CITY OF CONWAY, ARKANSAS HISTORIC DISTRICT COMMISSION

HISTORIC DISTRICT COMMISSION

August 28, 2023

2025 Robinson Ave—Lot Layout & Proposed Fence

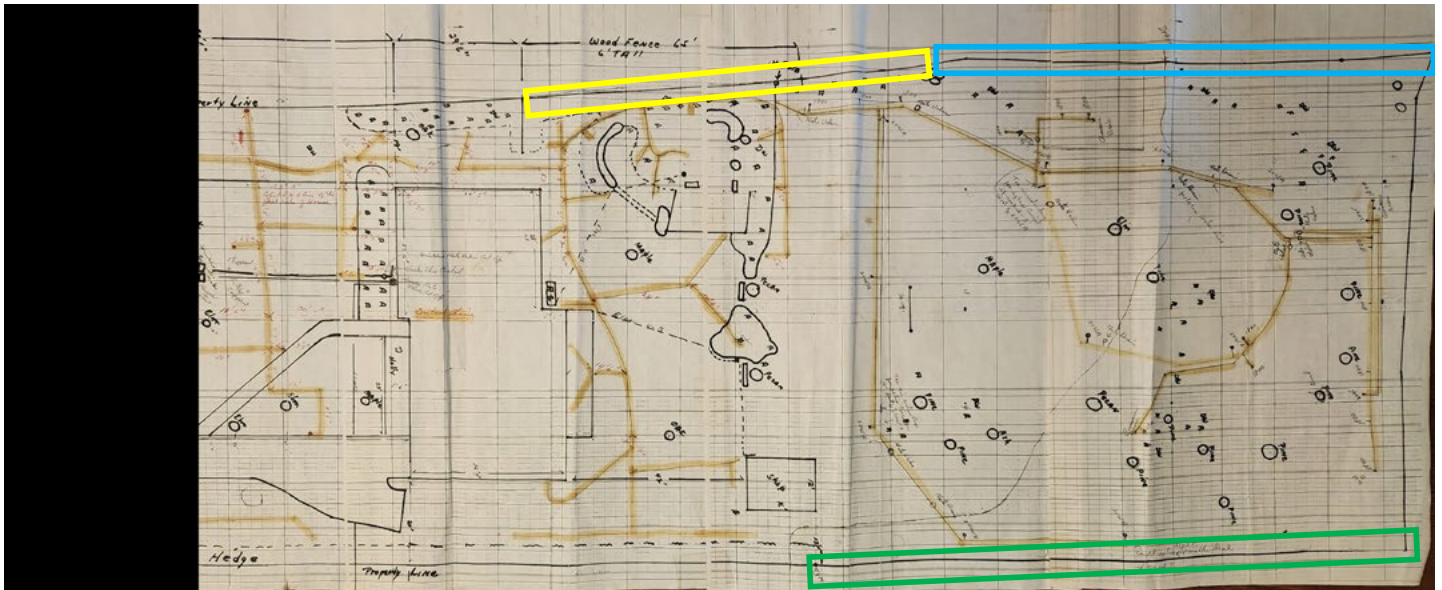
Applicant is not proposing any fence in the front yard. Proposed work is along the east and west side property lines. It is not visible from the public right-of-way. The applicant proposes extension of an existing chain link fence. The applicant would like to replace the existing shadowbox fence with classic dog ear fence. The applicant requests that an exception be made to the upper two feet, 50% opacity requirement. This is due to a desire for increased privacy.

1. Fence shall not exceed 6ft in height.
2. Work shall be limited to the side and rear yards.
3. Protect significant existing trees (8" or greater in diameter at breast height) and plants during construction.
4. Extension of existing chain link fence shall be limited to that shown on site plan with the remaining fence repair/replacement being limited to [wood] dog ear picket fence.

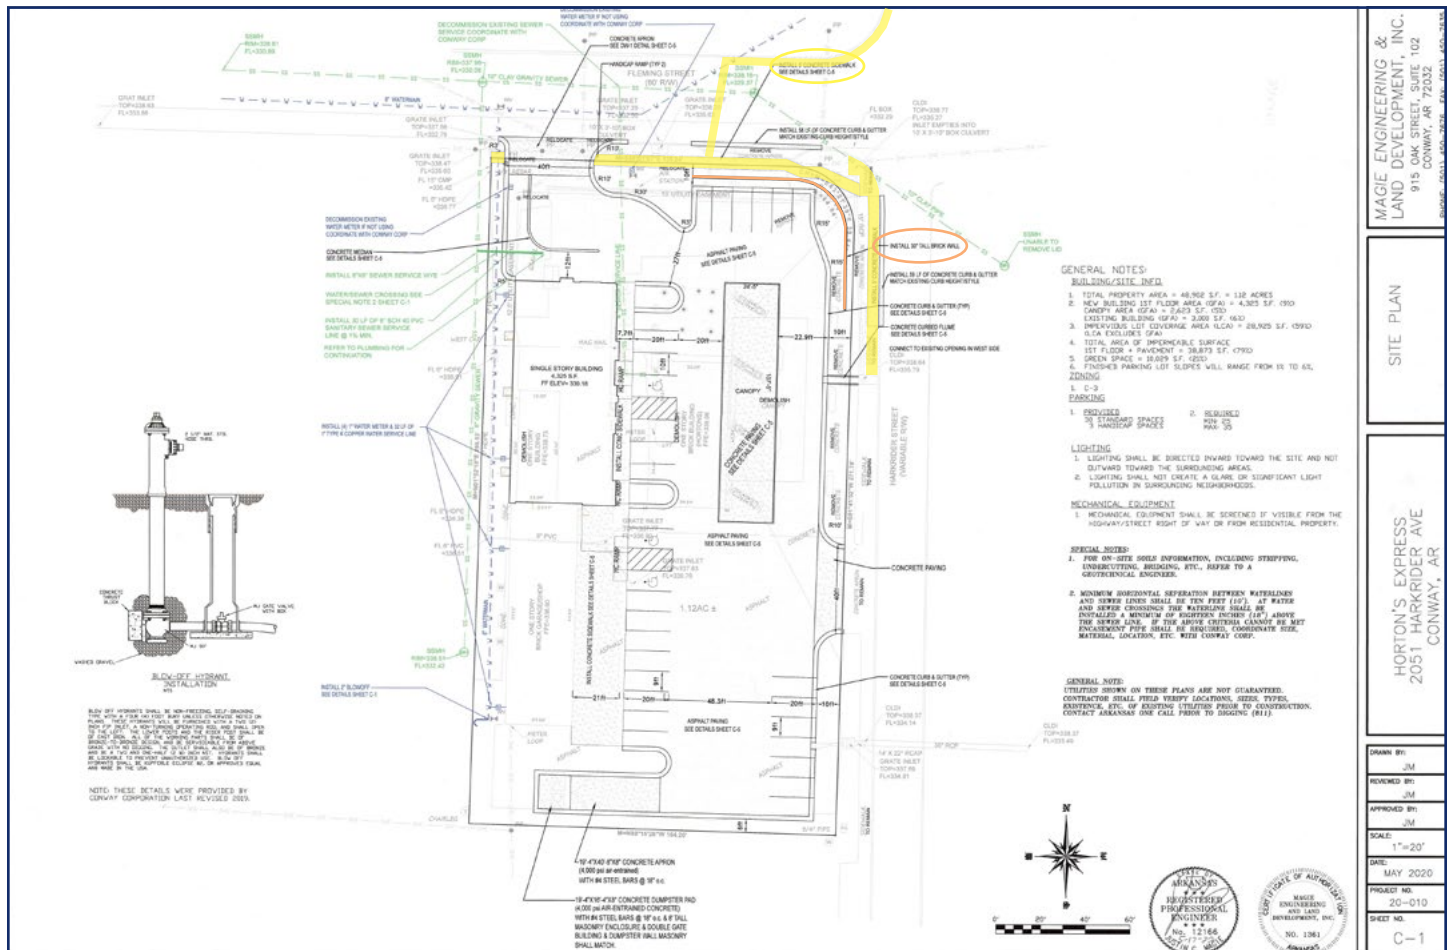
There are street frontages on Fleming St and Harkrider St. Staff recommends that the sidewalk on Fleming St be constructed and the sidewalk on Harkrider St be repaired. At the time of a site visit, staff noticed pedestrians along the Fleming St frontage, highlighting the "essential pedestrian element" portion of the regulation.

Sidewalk construction along all street frontages (including Fleming) was a condition of approval for the development of a duplex at 2022 Jefferson St which is 3 lots west of the site.

Sidewalks are prevalent in the area.

Utility poles and easements did not preclude the applicant from proposing a sidewalk on the Site Development Review plans.

A low street wall has been constructed. Staff acknowledges that the low street wall may need to be moved further south to accommodate a 5' wide sidewalk. Alternatively, Planning Staff can support a 5' sidewalk from back of curb on Fleming St.

Staff recommends denial of the request to pay sidewalk in-lieu fees, with the following conditions:

1. The sidewalks along Harkrider St shall remain in place and shall be replaced/repared if damaged during construction.
2. Prior to issuance of a Certificate of Appropriateness, applicant shall submit a site plan showing the location of the proposed sidewalk. Sidewalks shall be sited either from back of curb or in another feasible location so long as they are shown along the full extent of the site boundary along Fleming St. The site plan shall show sidewalks that are at least 5' wide.
